2.2 Predicted Noise Levels

Quoting from the Peer Reviewed study of the Noise Assessment for this ACEN project

Figure 4: Highest predicted noise level contours for GE 6.0-164, dB LAeq

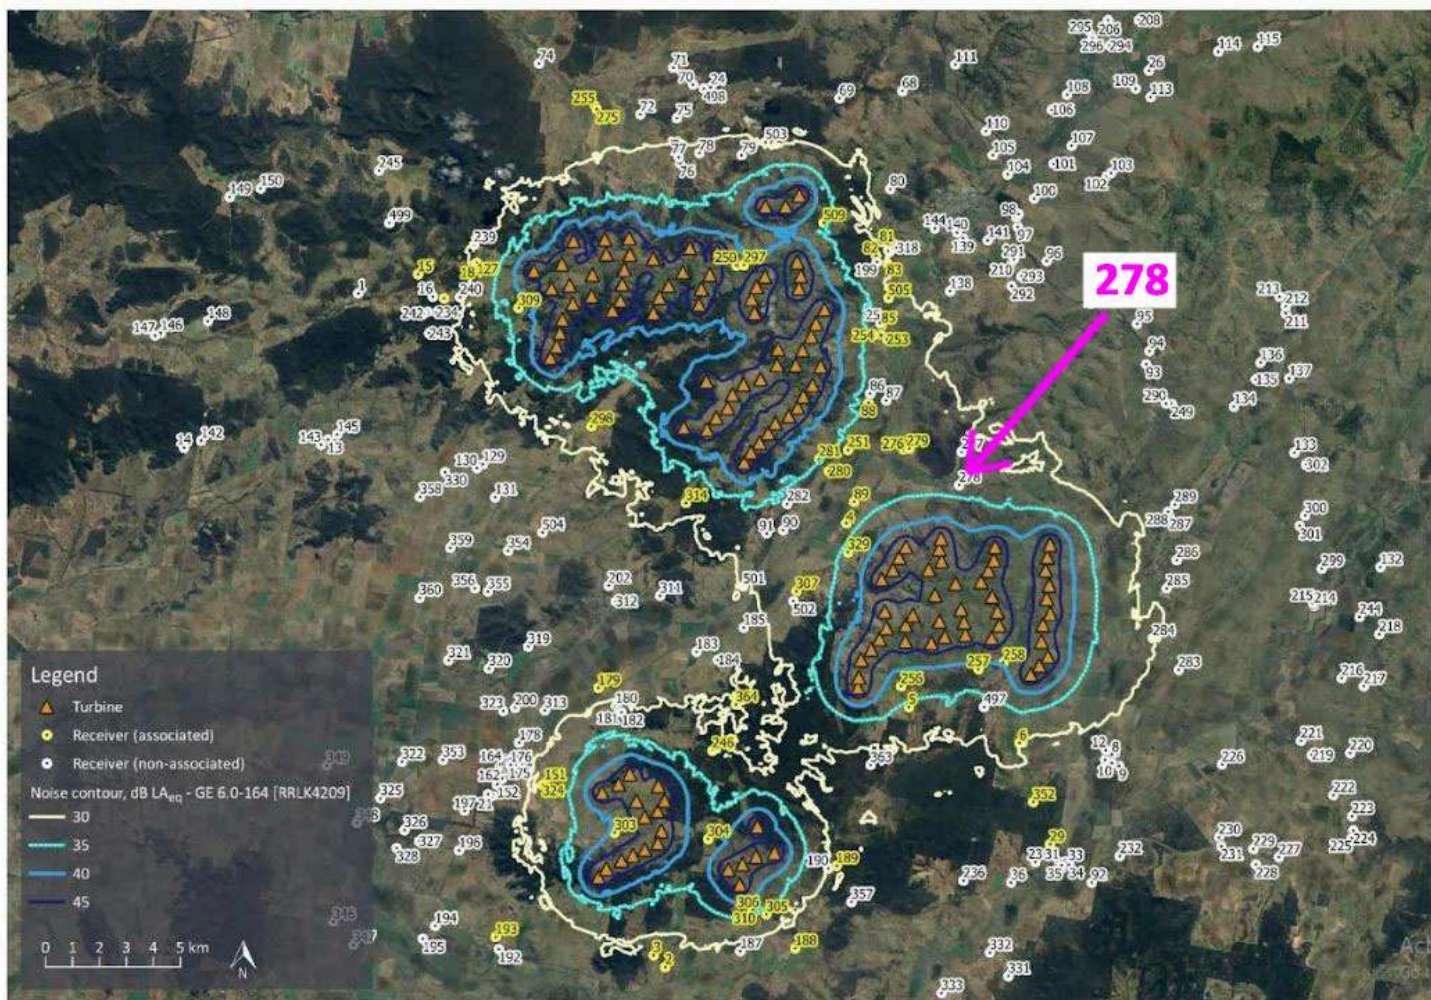
It is surprising for an EIS, that **must** include *‘completed technical studies, including an accurate noise impact assessment for relevant dwellings is undertaken consistent with the requirements of the Noise Assessment Bulletin’*, to state

that the wind turbine layout, turbine type, the consideration of other matters such as tonality, low frequency noise and sound power levels can all change and are issues that will be considered **after** approval of the EIS.
